R.F. Accelerating Cavities for RHIC

MEMORANDUM

SUBJECT: R.F. Accelerating Cavities for RHIC

Fig 1

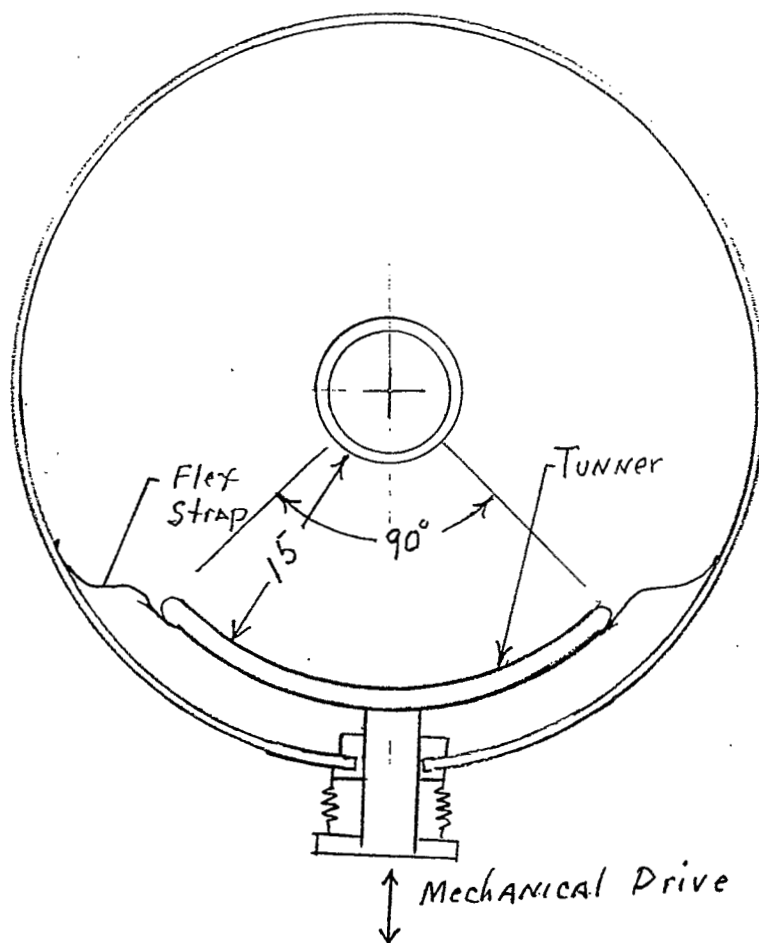
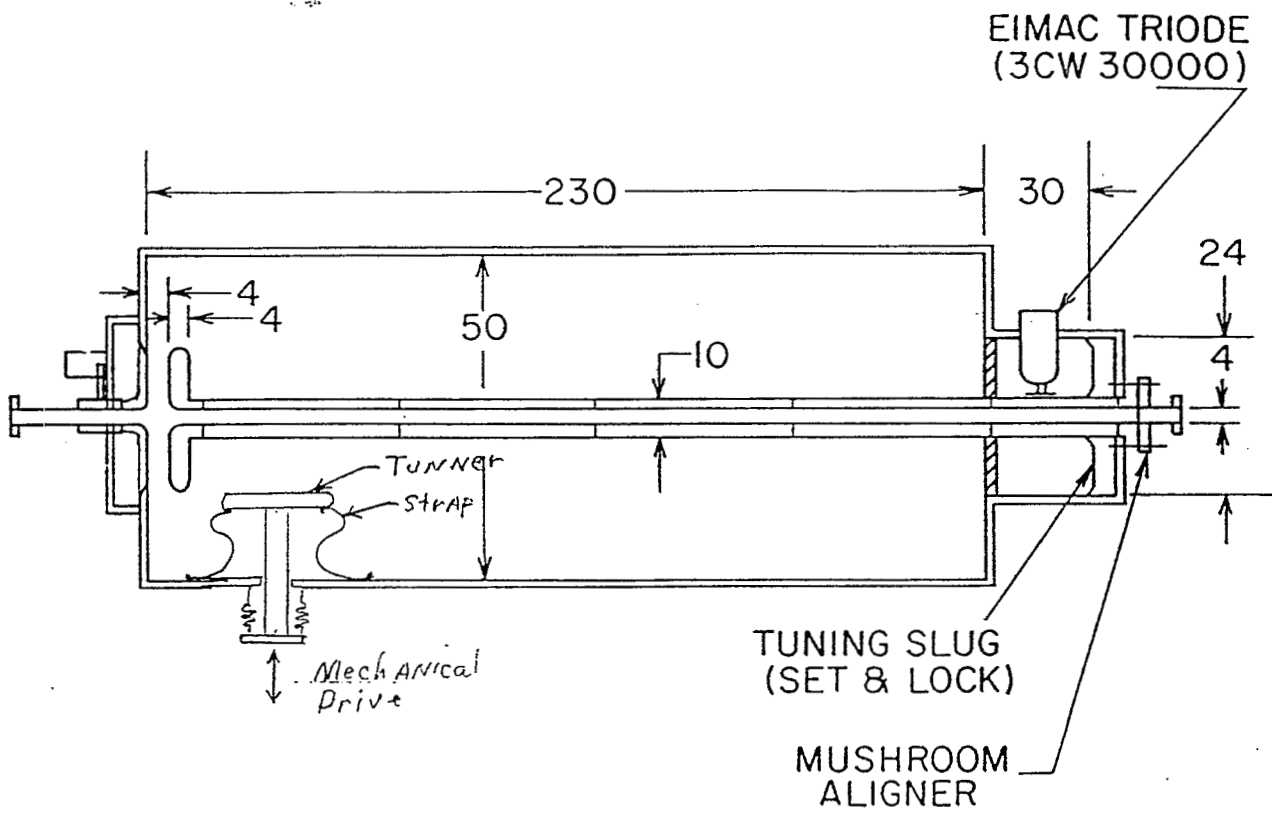
I have also reviewed the high voltage r. f. cavity design described by M. Puglisi in RHIC Technical Note No. 6. As you know this cavity design was the basis for the design presented in the RHIC Conceptual Design where it was modified to include a frequency tuning feature, (see page 241). The design is sound with one exception. I don't like using the accelerating gap spacing as a means of adjusting the frequency. I believe that stress flexure and motion should be avoided in this high gradient region. Instead I would suggest a "side" tuning plunger which I believe is more conventional. I have sketched a design of this type, (see attached Fig. 1).

This plunger is mechanically positioned by an external mechanism working through a bellows to accomplish the desired tuning. The electrical connection to the plunger is accomplished by flexible copper straps. Sliding r.f. joints in a vacuum is in my view a no-no. The required motion for normal operation is small, see attached tuning-position curve, but the full range requested in the Conceptual Design is available.
